Author's Reply to the Review Report (Reviewer 2)

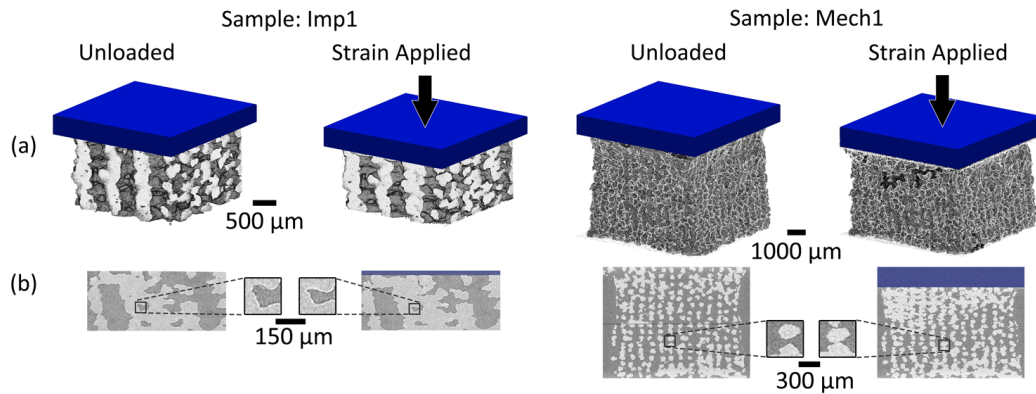
Point 20: Figure 4. Could authors include microCT cross-sections of both samples in the unloaded and loaded configuration to demonstrate the strut's deformation? Which material were the platens made of?

Response 20: Thank you for the suggestion, we agree that adding micro-CT cross-sections is useful. The platens were made of polyoxymethylene (Delrin).

We have added cross-sections of both samples under both loading configurations to Figure 4 (copied below) with additional detail in the accompanying caption. Clarification of the platen material has been added to line 148.

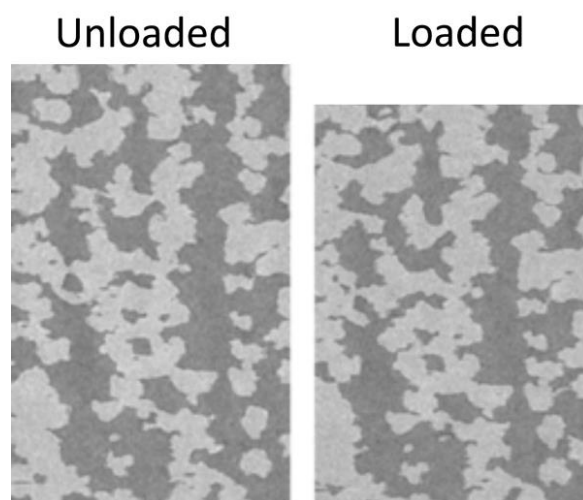
Point 25: Figure 10. How to authors explain the noise at the top of Mech 2 implant? What did they observe in the microCT images?

Response 25: We thank the reviewer for this is very good question. The micro-CT images themselves were satisfactory and showed the top platen compressing the sample as intended. For the reviewer's interest we have included below an example region showing the sample undergoing loading. We believe that the inconsistent deformation demonstrated at the top of Mech2 was caused by a combination of: the large single loading step causing trouble with feature tracking and unusual scaffold behaviour in certain regions with this specific sample caused during the manufacturing process.

We have elaborated on potential causes on lines 322-324 and 650-659 in the revised manuscript.
